# ADDENDUM NO. 1

**July 7, 2026**

## **SCHOOL CITY OF HOBART VARSITY BASEBALL AND SOFTBALL TURF FIELDS PROJECT**

**Addendum One (AD.01)** to the drawings and specifications prepared by Gibraltar Design for **Hobart High School Baseball and Softball Field Replacement and Related Work** for School City of Hobart, Hobart, Indiana.

| © GIBALTAR DESIGN | SHEET<br><b>C-101</b> |

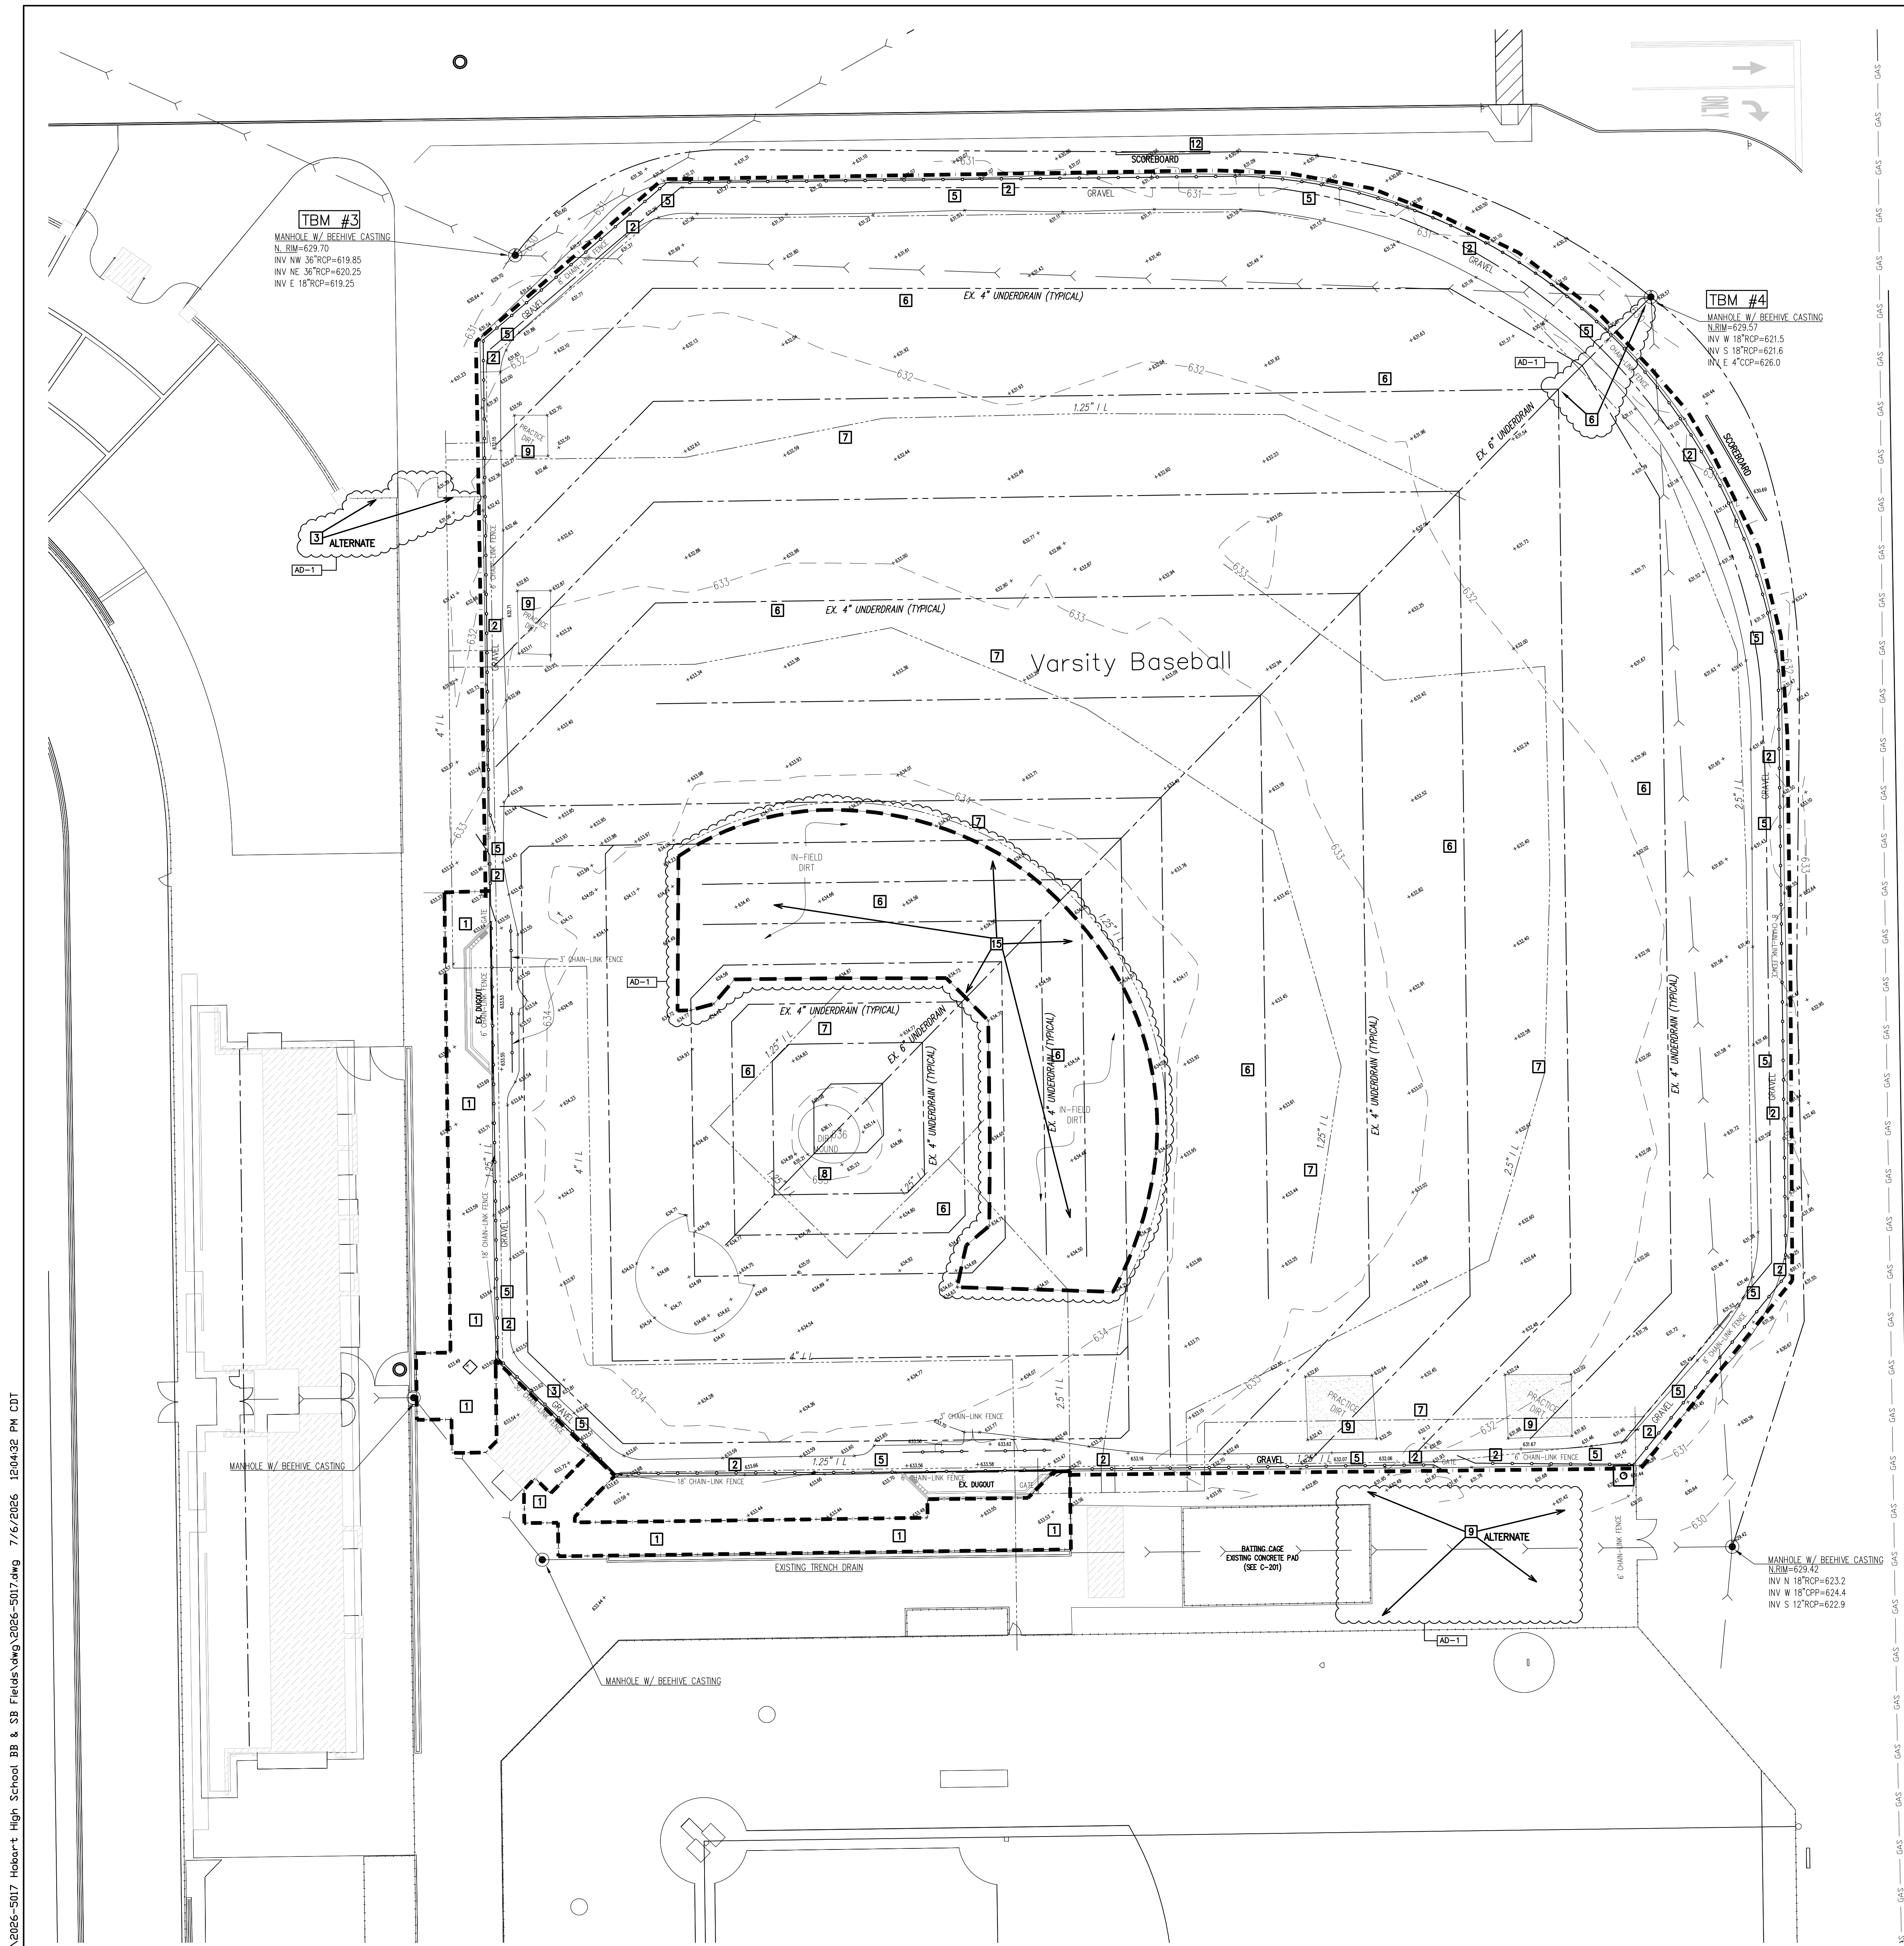
**3. Sheet C-101**

A. Refer to full-size drawing for revisions.
